ADELL CENTER PRO: FIRST AMENDMENT JZ18-24 with Rezoning 18.724

ADELL CENTER PRO FIRST AMENDMENT JZ 18-24 AND ZONING MAP AMENDMENT 18.724

Consideration at the request of Orville Properties, LLC for Planning Commission’s recommendation to the City Council to approve an amendment to the previously-approved Planned Rezoning Overlay (PRO) Plan and Agreement. The subject property is approximately 23 acres and is located on Expo Center Drive (now Adell Center Drive), north of Grand River Avenue and south of I-96 in Section 15. The applicant is proposing to develop the property as a multi-unit commercial development. The current amendment is requested as changes are proposed to the approved layout for Units 6 and 7, common landscape areas, building signage, and location of accessory units.

PRO CONCEPT PLAN

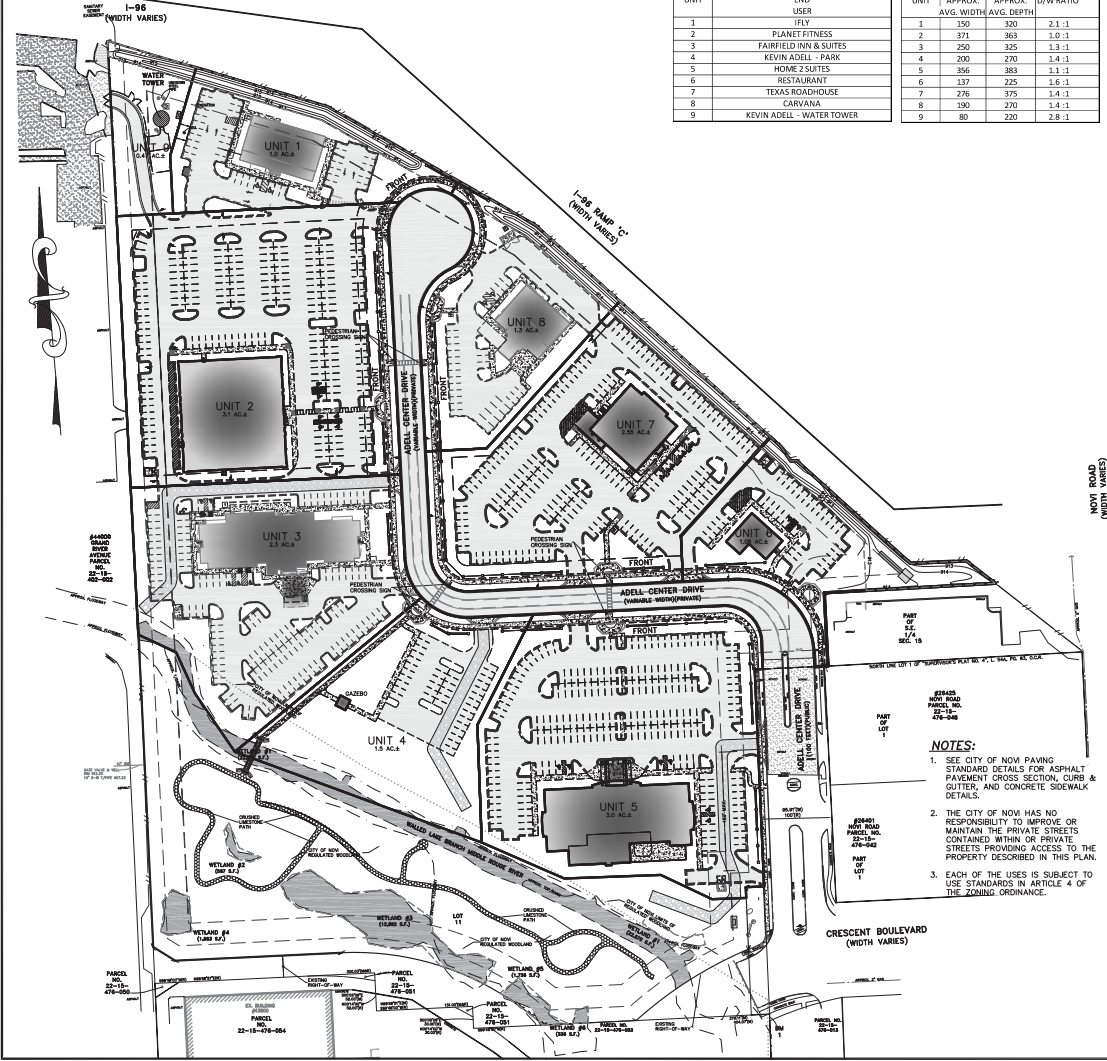
1. The applicant shall provide a formal revised submittal to provide sufficient time for staff and consultants to review the revised layout for Unit 6 dated 03-07-19, as submitted with the response letter dated 03-07-2019. Additional comments may be warranted since Unit 6 has been reduced in size from the approved PRO Plan and detailed information was not provided in time for a complete review by staff);

1. The applicant shall submit a formal revised submittal to provide sufficient time for staff and consultants to review the revised layout for Unit 6 dated 03-07-19, as submitted with the response letter dated 03-07-2019. Additional comments may be warranted;
2. The applicant shall provide necessary information to identify the necessary deviations from Chapter 28, Signs from City Code of Ordinances for Unit 2 –Planet Fitness prior to the City Council's consideration for tentative approval of PRO Concept plan;

③ EAST ELEVATION
1/8" = 1'-0"

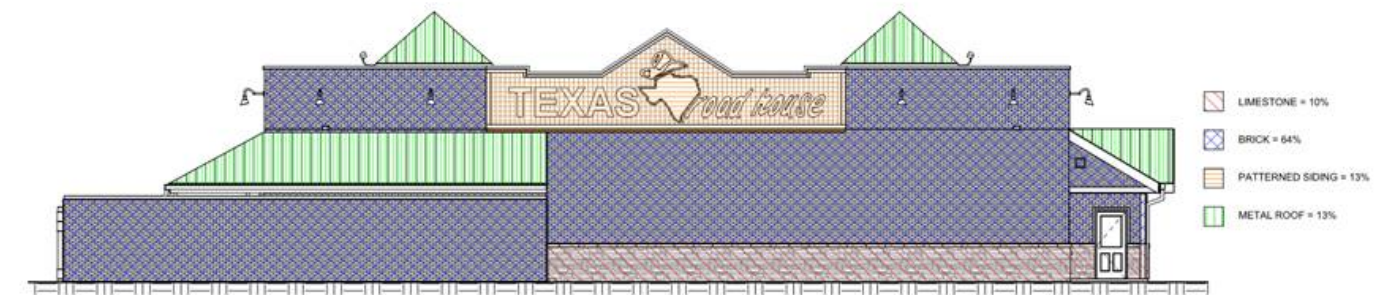
- e. Façade deviation from Section 5.15 to allow exceeding the maximum allowable percentages for standing seam metal for the building on Unit 7 (A maximum of 25% standing seam metal roof is allowed, 35% on East elevation and 29% on west elevation is proposed);

4. Façade deviation to allow the following allowable percentages listed in section 5.15 of Zoning Ordinance for the building on Unit 7 as listed below

- a. A maximum of 25% standing seam metal roof id allowed, 35% on East elevation and 29% on west elevation proposed;
